Nafisa Apparels Ltd.

7th March 2015

Building Observations

Highly-stressed columns (Original building)

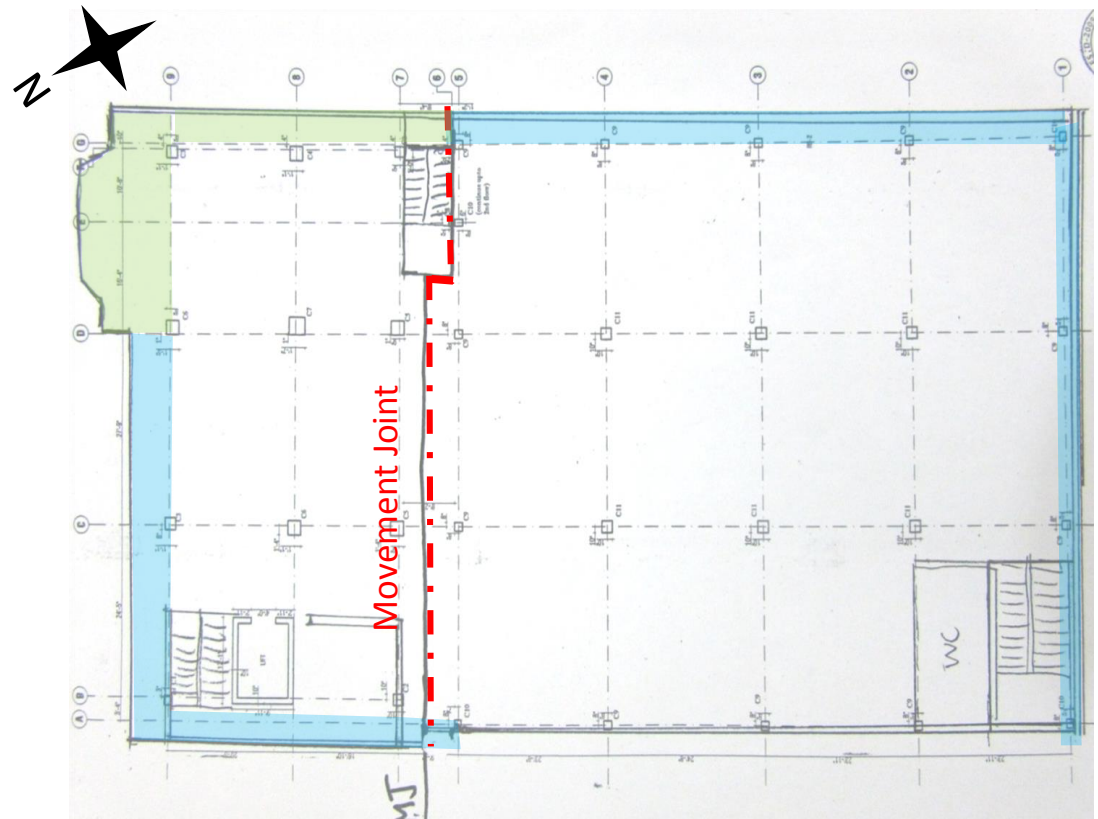
- Building during construction phase (Ref. Google Maps – photo c. 2013)
- Additional floor has been added to older part of building behind (previously 5 storey). The soils report from 2004 also refers to a 5 storey building.

Columns at ground floor level appear to be stressed in excess of normal design limits

No beams in 1st floor cantilever (Extension)

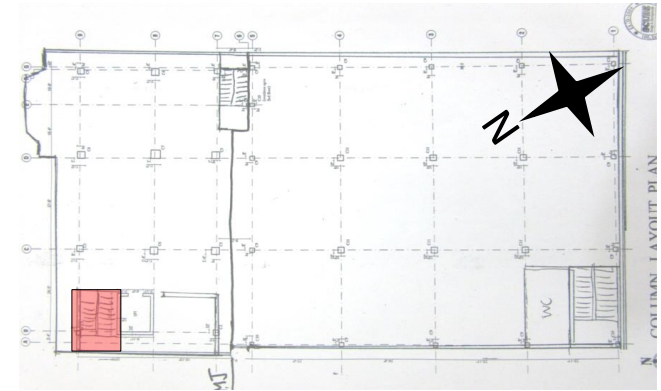
No Cantilever beam at any level

No Cantilever beam at 1st floor level, all other floors have cantilever beams.
